**GEOTECHNICAL AND GEOLOGIC HAZARD INVESTIGATION
The Ridge Nests Development
Powder Mountain Resort
Weber and Cache Counties, Utah**

IGES Project No. 01628-008

July 15, 2016

C:\DOCUME~1\DAVIDG\DESKTOP\01628008\B1.PL2 Run By: DAG 9/1/2015 2:04PM

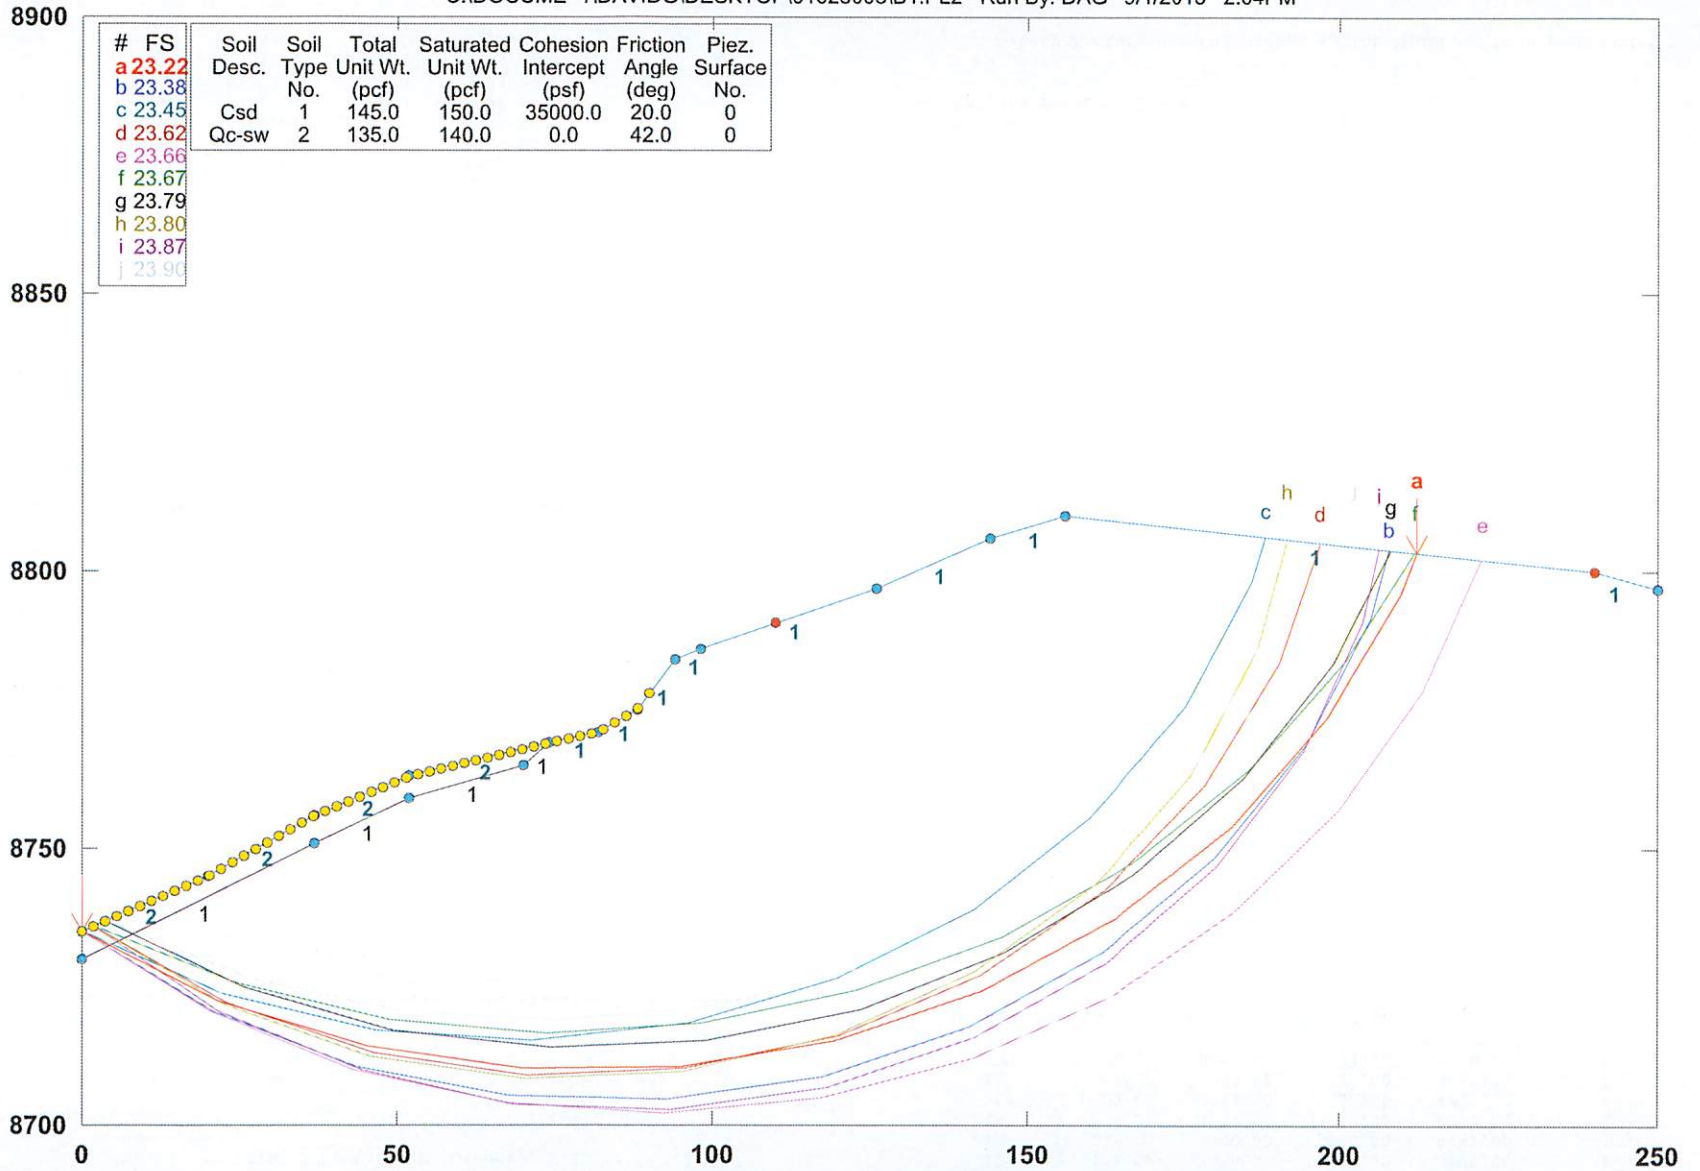
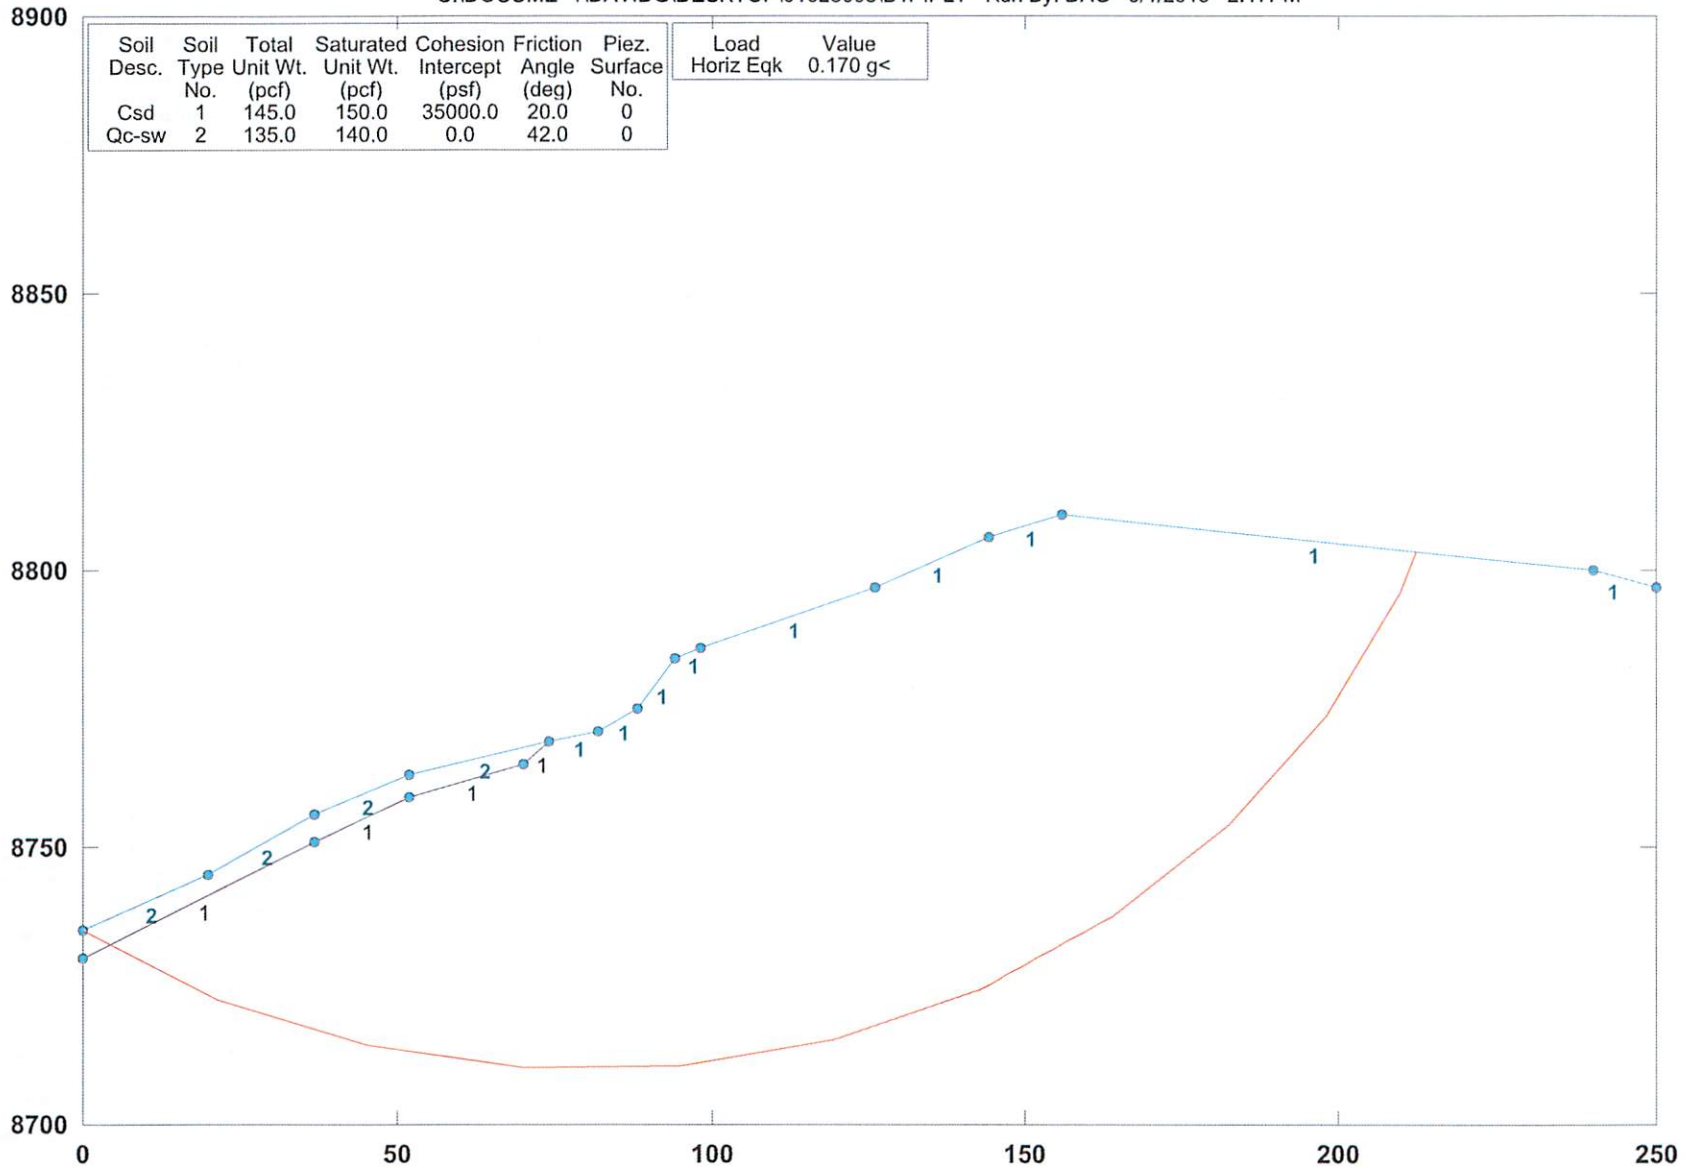
Comment No. 1

The global stability of the slope was modeled using gSTABL7 slope stability software. Bishop's Method and Janbu's Simplified method was used to model the slope, as appropriate. For our analysis, we have assessed two representative sections, Section A-A' and Section B-B', illustrated on Plate 1 (*Geologic Map*) and the *Geologic Cross-Sections*, Figure 1, attached. Calculations for stability were developed by searching for the minimum factor-of-safety for both a circular-type failure and a block-type (translational) failure. For the circular analysis model, arcuate failure surfaces and homogenous earth materials were assumed. For the block analysis, anisotropic strength parameters in the bedrock was assumed, based on the apparent dip of bedding. A minimum static factor-of-safety of 1.5 and seismic factor-of-safety of 1.0 (global stability) was considered acceptable for this project considering the available information and design assumptions.

Photo 1. Finer-grained dolomite lithology, exhibiting thinner beds and blocky jointing.

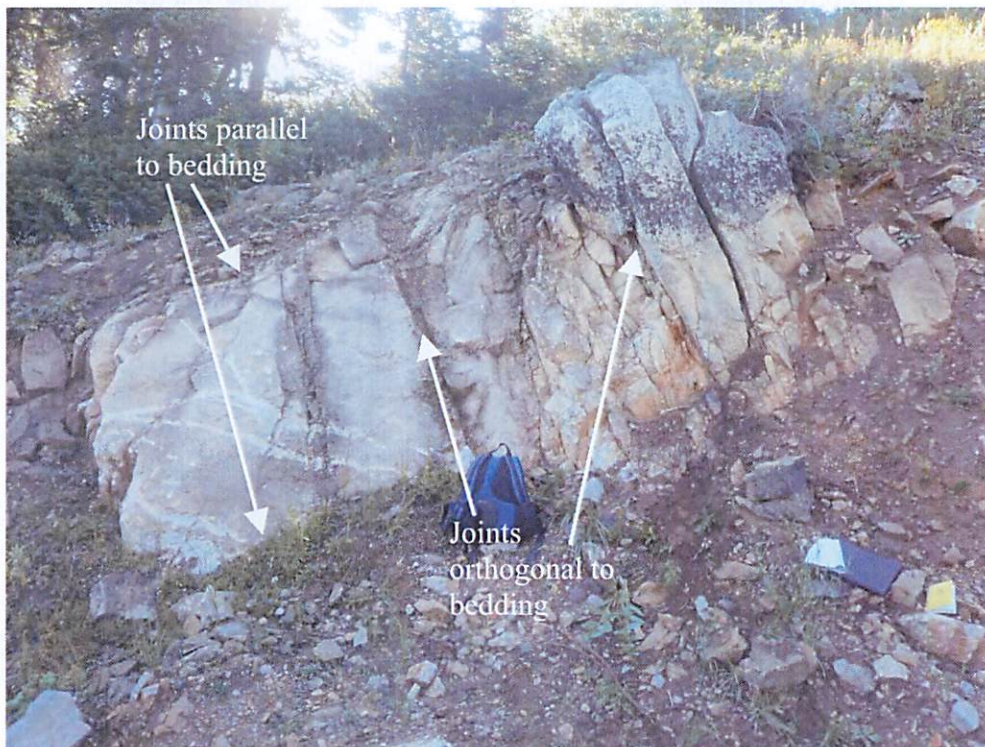
"The September 23, 2015, IGES response letter did not describe the properties of the bedding and/or jointing for incorporation into the slope stability analyses, e.g., properties such as, strike and dip, degree of fracturing (generally controlled by the number of joints in a given direction), persistence of jointing, spacing of jointing, roughness of joint surface, open and/or closed joints, joint coatings and infillings, etc.

In response to the comment, the following additional details are provided: bedrock was found to be largely moderately fractured (distance between fractures ~0.5-1.0 feet) to little fractured (distance between fractures ~1.0-4.0 feet), with localized areas of intense fracturing (distance between fractures ~0.05-0.1 feet). Joint spacing was largely found to be a product of the lithology. The finer-grained dolomite lithologies were more thinly bedded, and therefore had a smaller distance (approximately 1 to 4 inches) between bedding plane joints. These lithologies also tended to fracture into rectangular blocks generally between 4 and 18 inches in length and width, and contained both bedding-confined and through-going fractures (Photo 1). Coarser-grained dolomite lithologies were more thickly bedded to massive, with bedding plane joints separated by between 6 inches to as much as several feet. These lithologies tended to fracture into rectangular blocks with highly variable dimensions, ranging in width and length from between a couple inches to several feet, though larger blocks (with dimensions of several feet x several feet x several feet) were most common (Photo 2). Most fracturing associated with the coarser-grained dolomite lithologies consisted of large through-going fractures.

Nearly all of the joints encountered in the field investigation were open, had slightly rough to rough surfaces, and did not contain a secondary mineralization, except rare calcite infilling in places. No slickensides were observed on any joint surface. Joint apertures varied from between a few millimeters to a couple inches in width. Joints with smaller apertures tended to be devoid of any sort of fill, while the larger aperture joints were often filled with soil. In the cases of the two identified faults, reddish gray silty gouge was found to be the fill material.
